ADDENDUM TWO

West Campus Maintenance Building Addition - 2026
2101 E. Coliseum Blvd
Fort Wayne, IN 46805

Commission No.: F25111

Addendum Date: 9 April 2026

C101

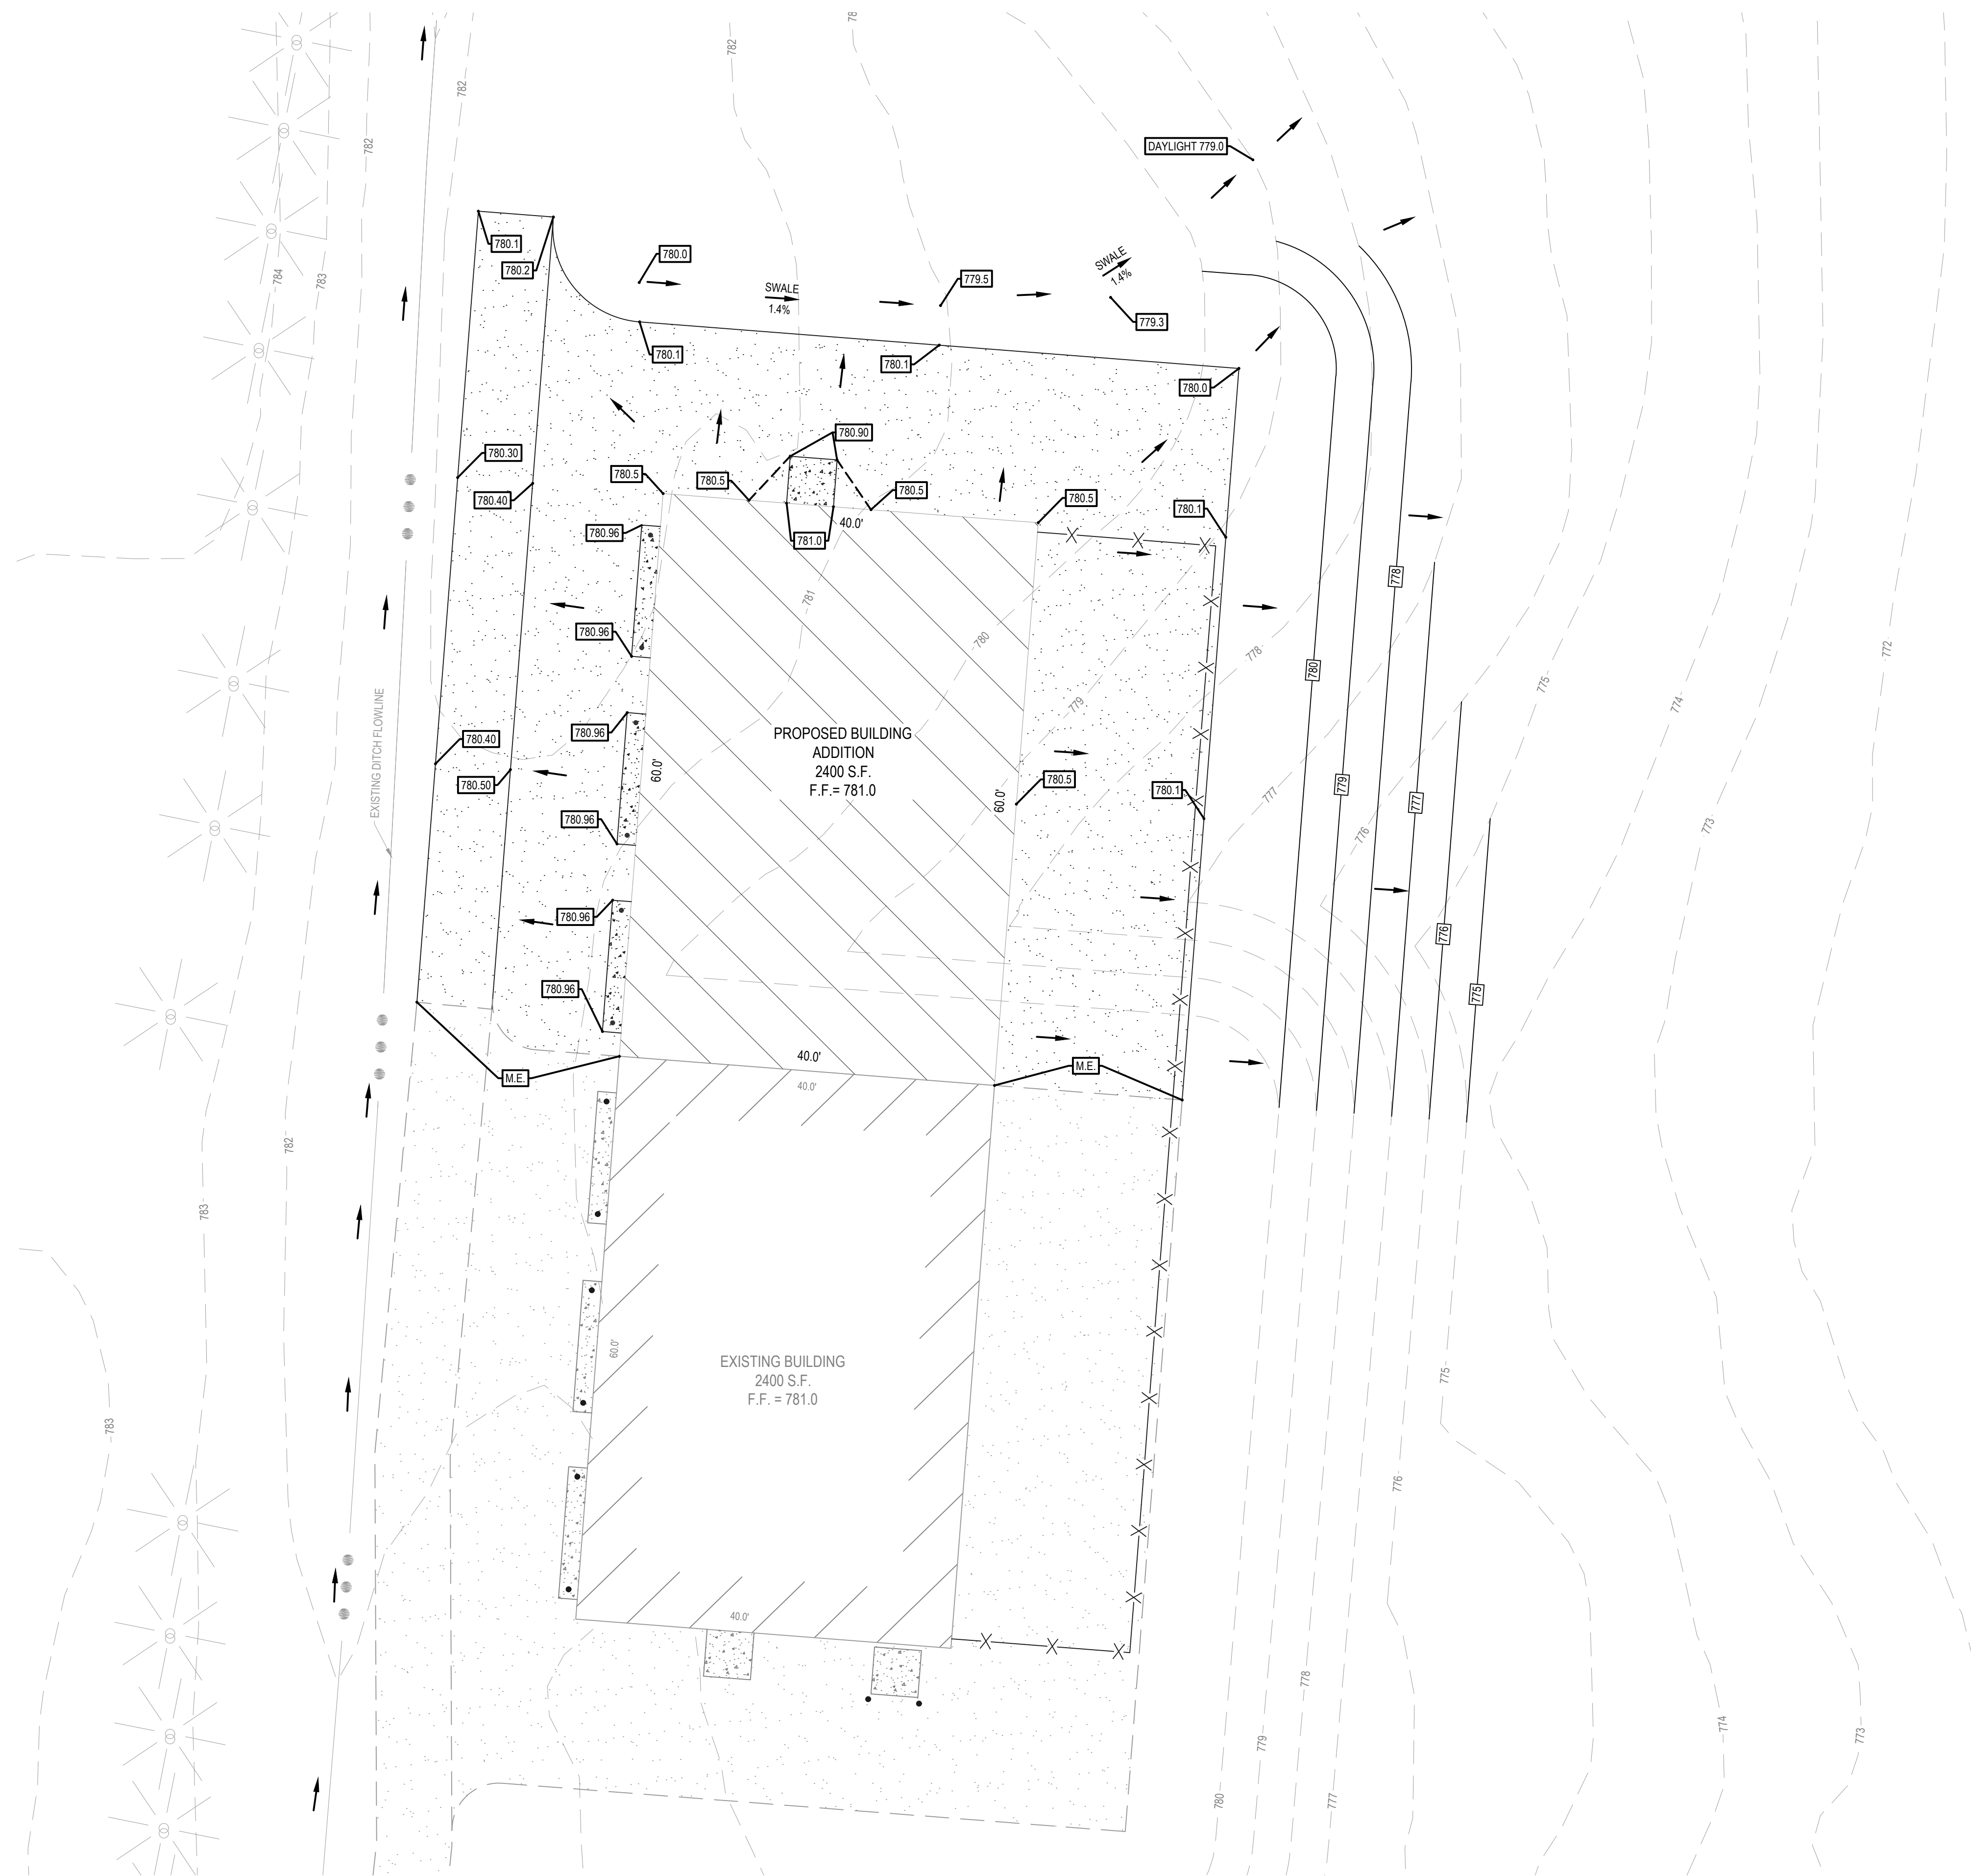
The demolition plan shows that we are to remove only the north 20' of existing fence. The east and south sides remain in place. The site layout plan is calling for all new fence. Are we to remove all of the existing fence and replace with new or leave the east and south sides of existing fence and just add on the new fence along the new addition?

Refer to revised drawings. The east and south sides of the existing fence are to remain. New portions are at the north and northeast sections.

Existing north gate to be salvaged and reinstalled. Refer to revised drawing. Stretches of new fencing still required at each side of gate as needed. Field verify sizes.

1 Chain Link Fence Detail
 NTS

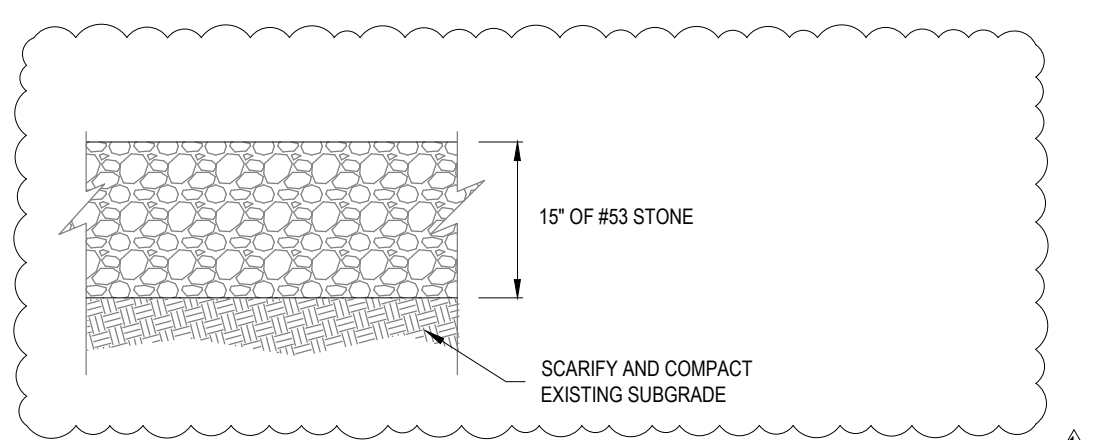
On sheet C800 detail 1 there is a note at the top that points to the top rail and says 1 5/8" o.d. top and bottom rail. The existing fence has bottom tension wire and not bottom rail. Should we install bottom tension wire to match the existing or install bottom rail?

Install bottom tension wire to match existing. See revised drawing.

2 Typical Stone Parking Section
 NTS

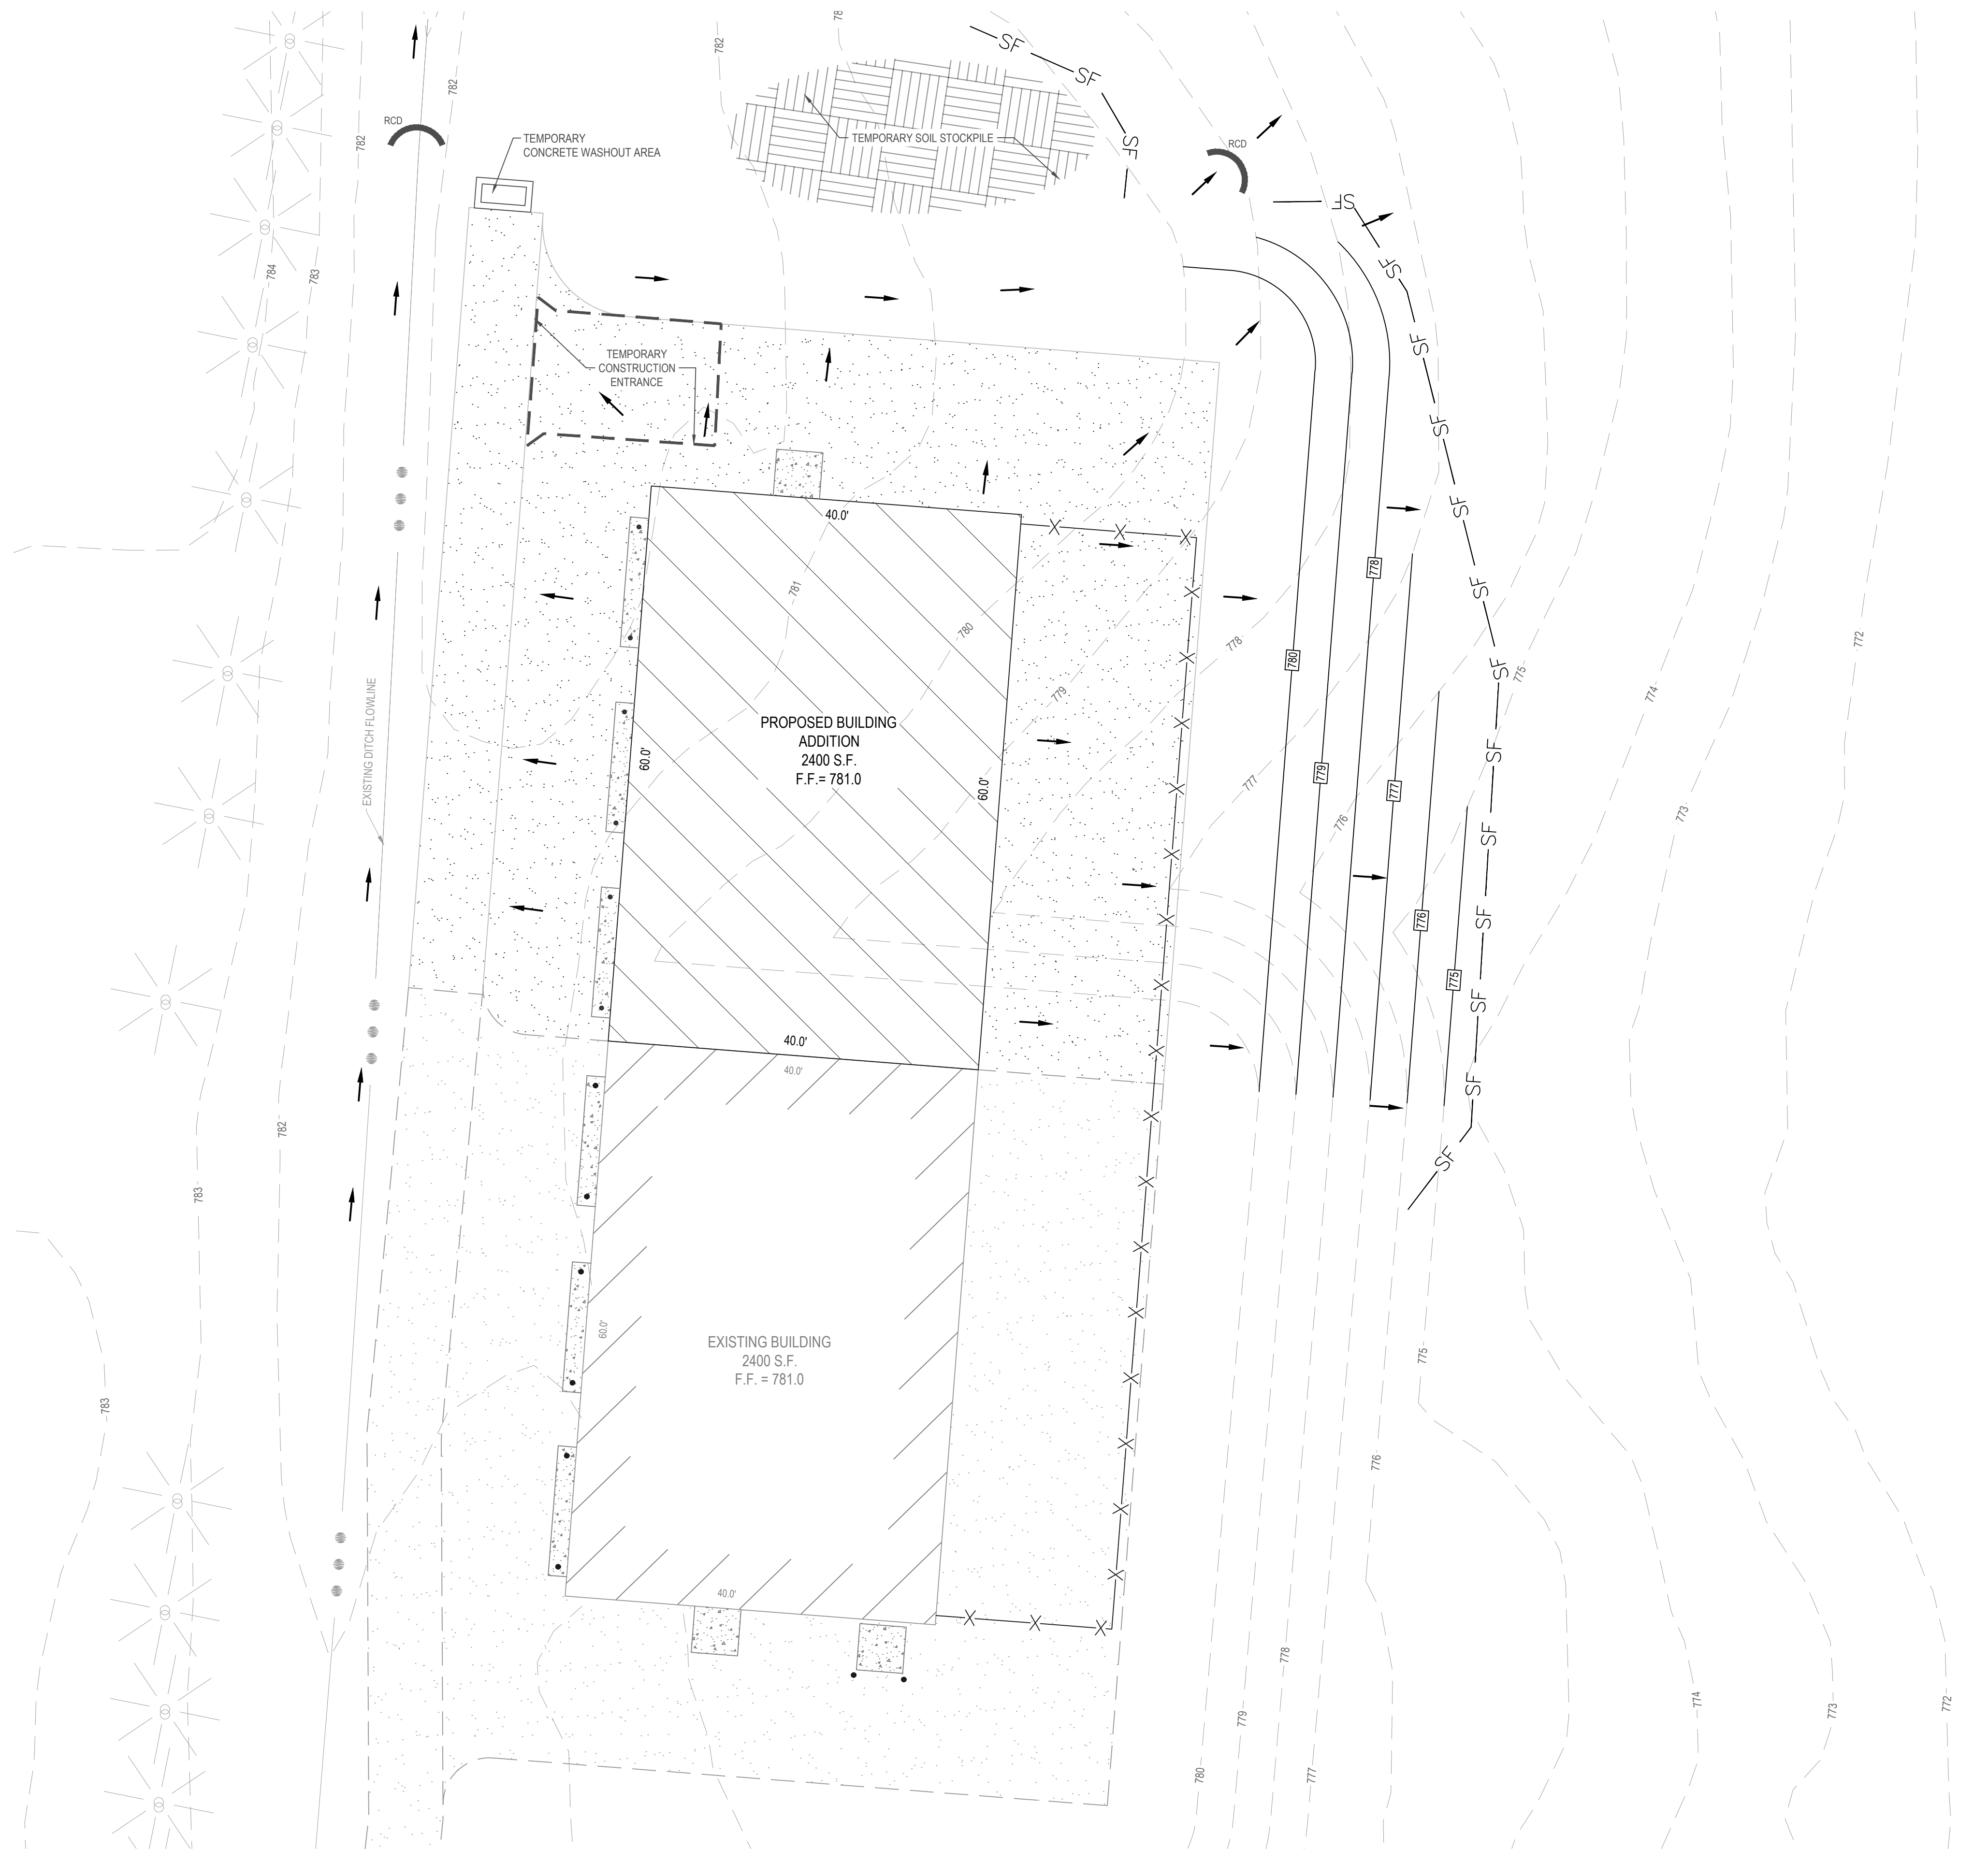
Typical Stone Road Section 2/C-800 does not specify what type of recycled base is to be use. Is the intent to use 24" of #53 rcycled base and 3" of #53 limestone surface? If not, please clarify what should be used for this section

This detail has been revised to read: 6-8" of top #73 stone over 4-8" base of #2 stone.

10 Typical Bollard
 3/4" = 1'-0"

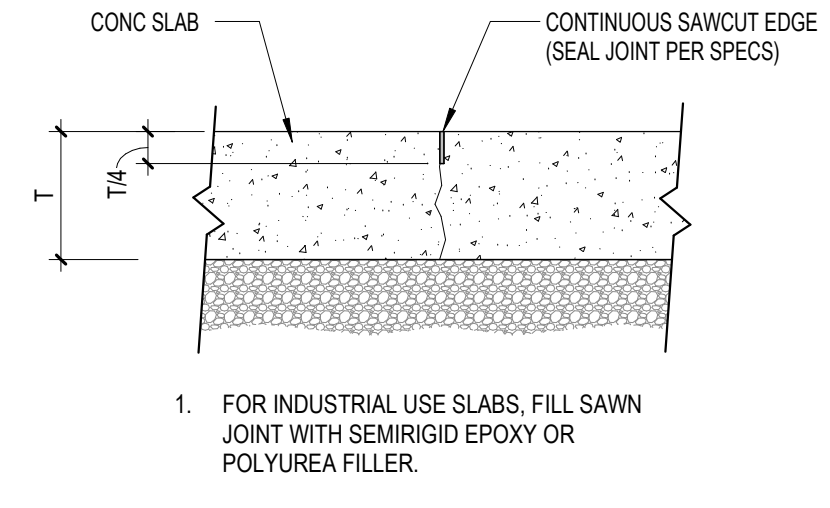
Do bollards need to be 8'? typical height is 7' because the poles come to the fab shop at 21'. Price is going to triple for 8' poles. Reference S402 detail 10.

Bollards revised to 7' height. Refer to updated drawing.
